Extension to the Carob Tree Restaurant Highgate, Camden

Title:
Comparison of Existing, Appeal and Newly Proposed Highgate Road Elevation

Scale: 1:50 (@A1)	Date: SEPT 11'
Drawn By: S.G.D	Checked: D.U.
Drawing No. SA/PL/101/17	Revision

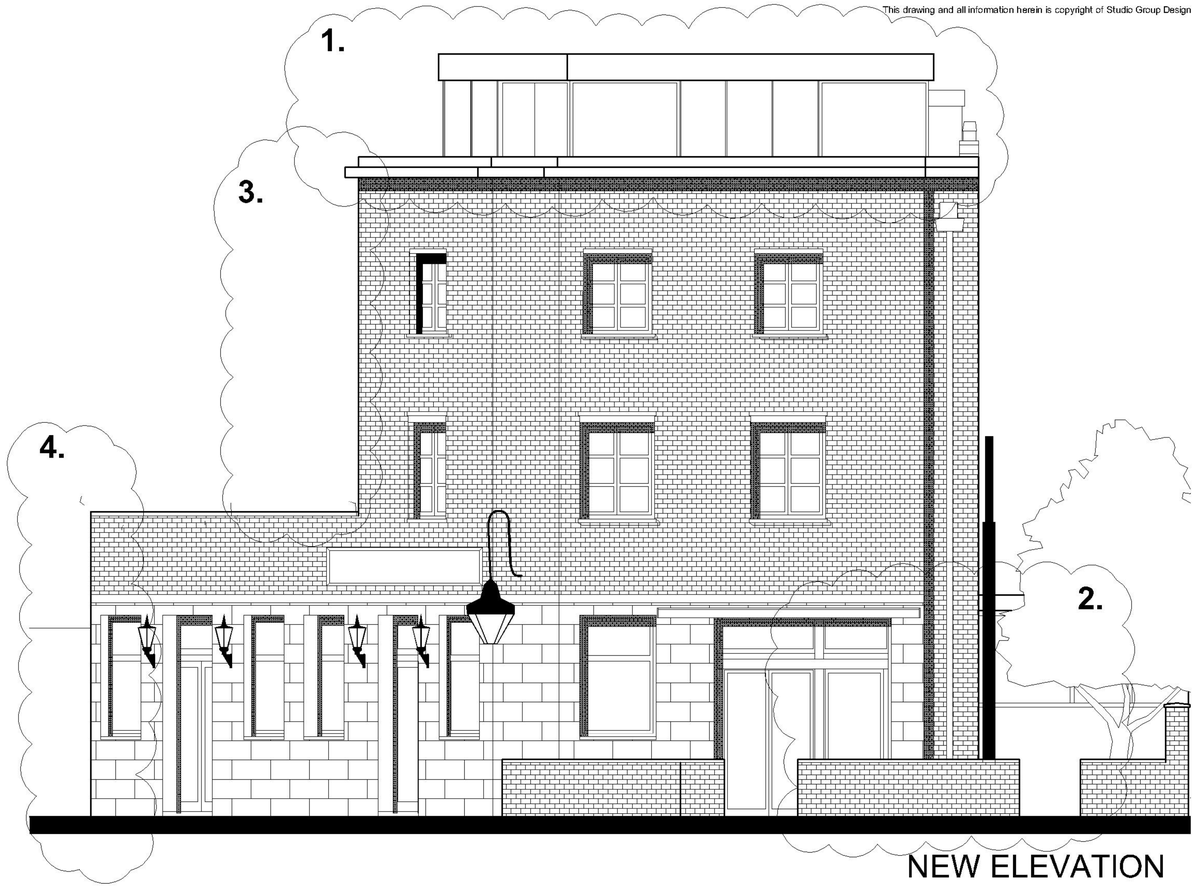
Main Changes from Appeal to New

1. The roof extension has been reduced in size in line with a reduction to the overall mass of the building on Swain's Lane. The size of the existing balcony has been redesigned to match existing.

2. Existing door opening extended to accommodate the new residential entrance, all materials to be as existing. New opening created in the wall for the residents with a new gate added to match existing.

3. Extension over first floor balcony removed reducing elevation mass to match existing.

4. The extension to the ground floor to accommodate the residential entrance has been removed, elevation to remain as existing.
